ADDENDUM NO. 1

Upgrade Electrical and Restrooms, Grandstands Missouri State Fairgrounds Sedalia, Missouri PROJECT NO. F2304-01

Bidders are hereby informed that the Construction Plans and/or Specifications are modified as follows:

GRANDSTAND POWER RISER (PHASE 2)

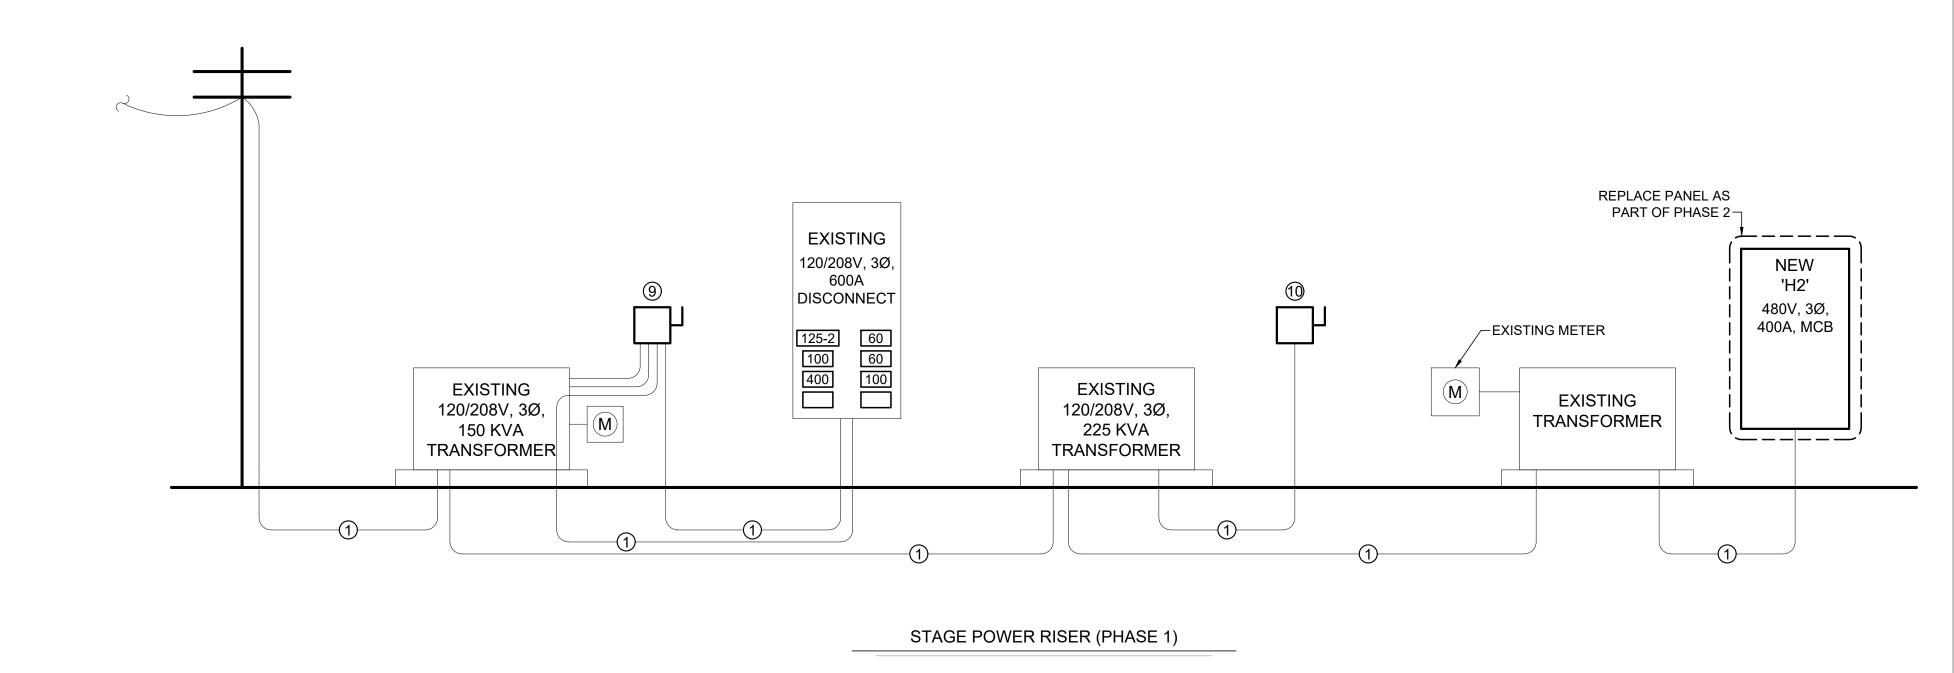
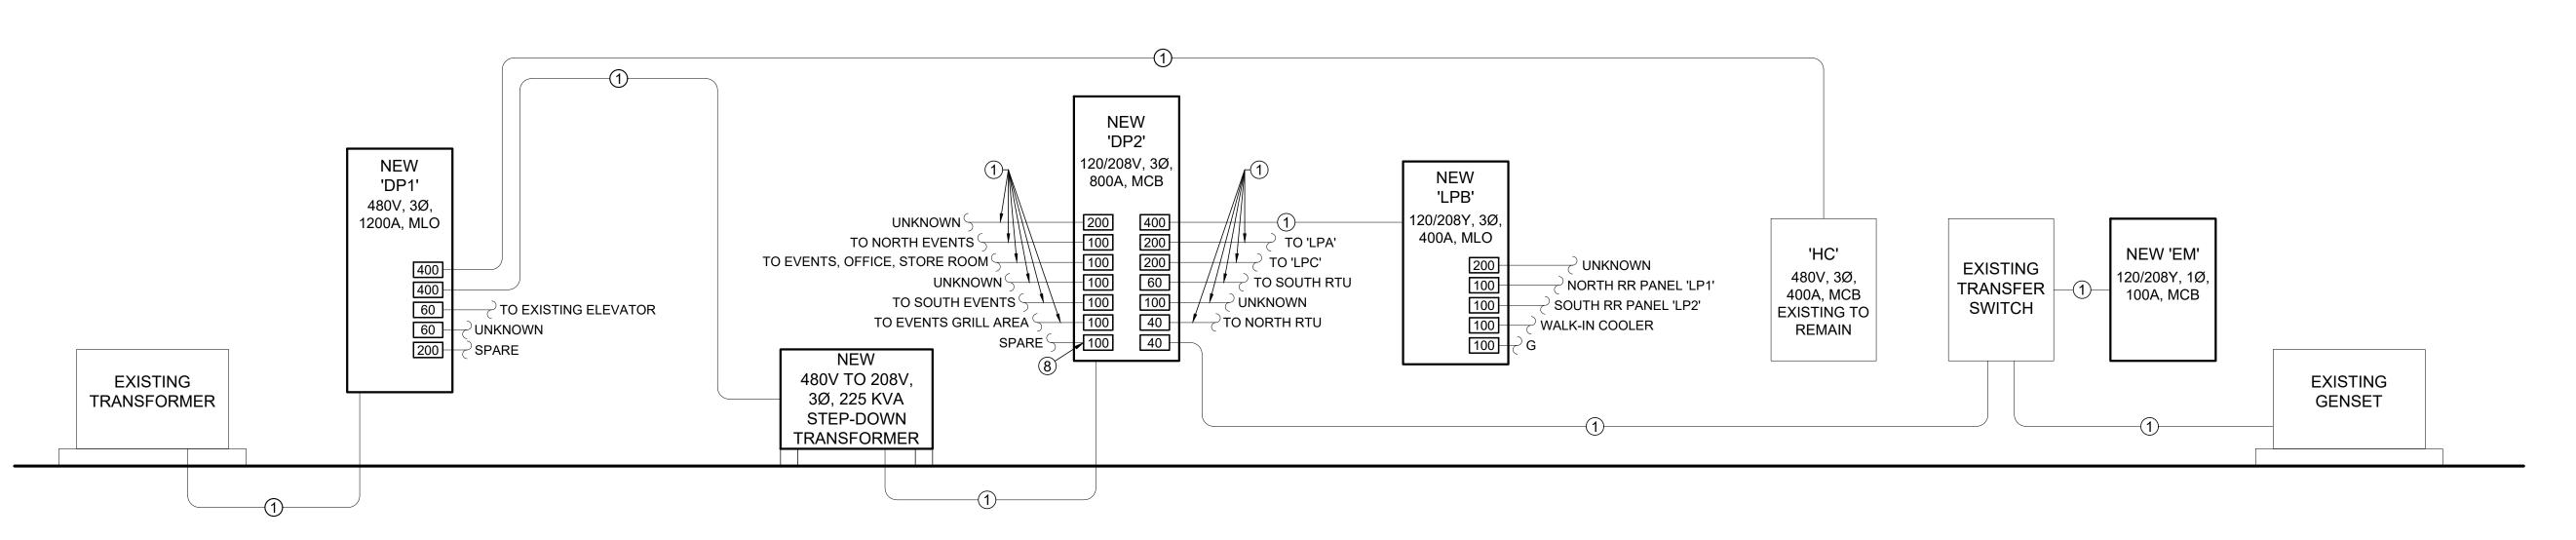
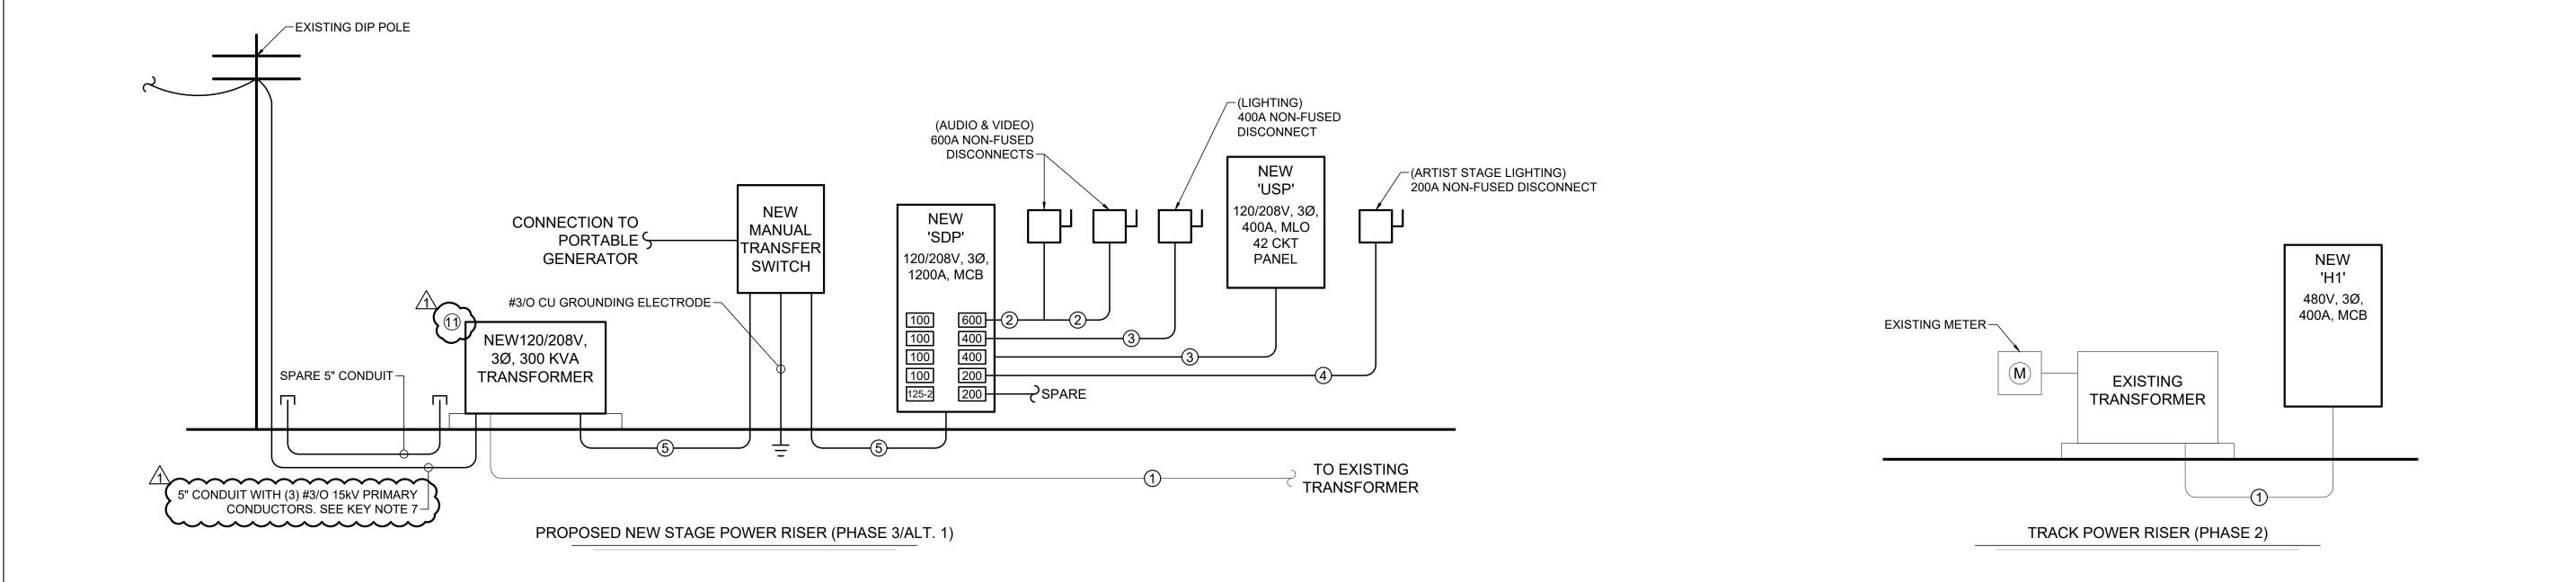
- 1. E-501
 - a. Please see the attached revised E-501 with an additional keynote and revised primary conduit tag,
- 2. E-502
 - a. Please see the attached revised E-502 with the addition of a detail for "Fixture (F2) detail
- 3. P-101
 - a. Please see the attached revised P-101 for changes to general plumbing notes, revised plumbing schedule, and the addition of a hose bib to the Phase 1 bathrooms.

- (7) PRIMARY CONDUCTORS SHALL MEET THE FOLLOWING SPECIFICATIONS. 3/0 URD CABLE, CLASS B STRAND, WITH A WATER BLOCKING STRAND FILLER TO SEAL AND FILL THE SPACE BETWEEN THE STRANDS, TO HAVE AN EXTENDED THERMO SETTING SEMI CONDUCTING CONDUCTOR SHIELD WHICH IS FREE STRIPPING FROM THE CONDUCTOR AND BONDED TO THE INSULATION, 220 MIL TREE RETARDANT UCC4202 OR BOREALIS 4212 INSULATION, EXTRUDED THERMOSETTING SEMI CONDUCTING INSULATION WITH CONTROLLED ADHESION TO THE INSULATION HAVING A REDUCED CONCENTRIC NEUTRAL OF 11-14AWG. BARE COPPER NEUTRAL WIRES & OVERALL ENCAPSULATING JACKET OF LINEAR LOW DENSITY POLYETHYLENE EXTRUDED TO FILL IN THE SPACE BETWEEN NEUTRAL WIRES, JACKET MUST BE FREE STRIPPING FROM THE UNDERLYING INSULATION SHIELD. CABLE TO BE TANDEM EXTRUDED & DRY CURED. CABLE TO BE CONSTRUCTED PER ICEA S-94-649, ICEA S-97-682 AND AEIC CS8.

A 12/170 GRD Y/ 7200. (11) TRANSFORMER PRIMARY VOLTAGE 12470 GRD Y/ 7200.
